Access Compliance Report Public Rights-of-Way (Pedestrian Signals)

Main Street: BALL_RD Cross Street: GILBERT_ST Location: NE

ADA ID: SGRK210927171332 Signal Type: One Push Button-Non APS Overall Compliance: No Severity Scores: BTN 1: 35 BTN 2: N/A No BTN: N/A

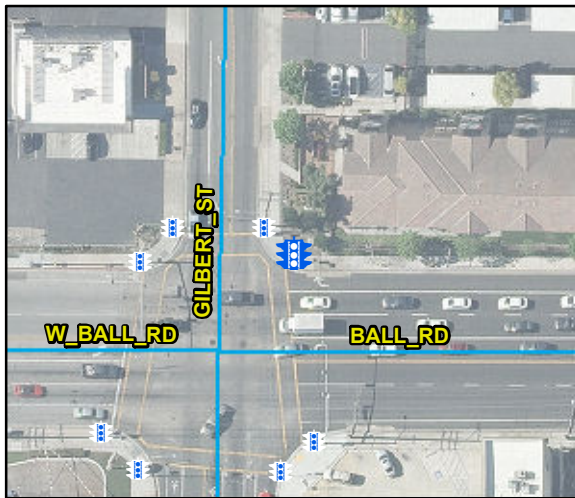
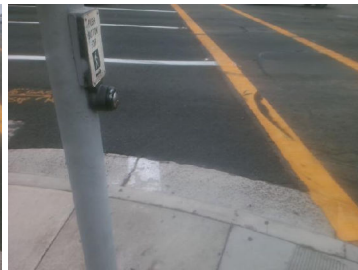
OC Std/PROW: MUTCD 4e.08, R404.2

Possible Solutions: Replace Signal Push Button With APS Button. Remove & Relocate Sign.
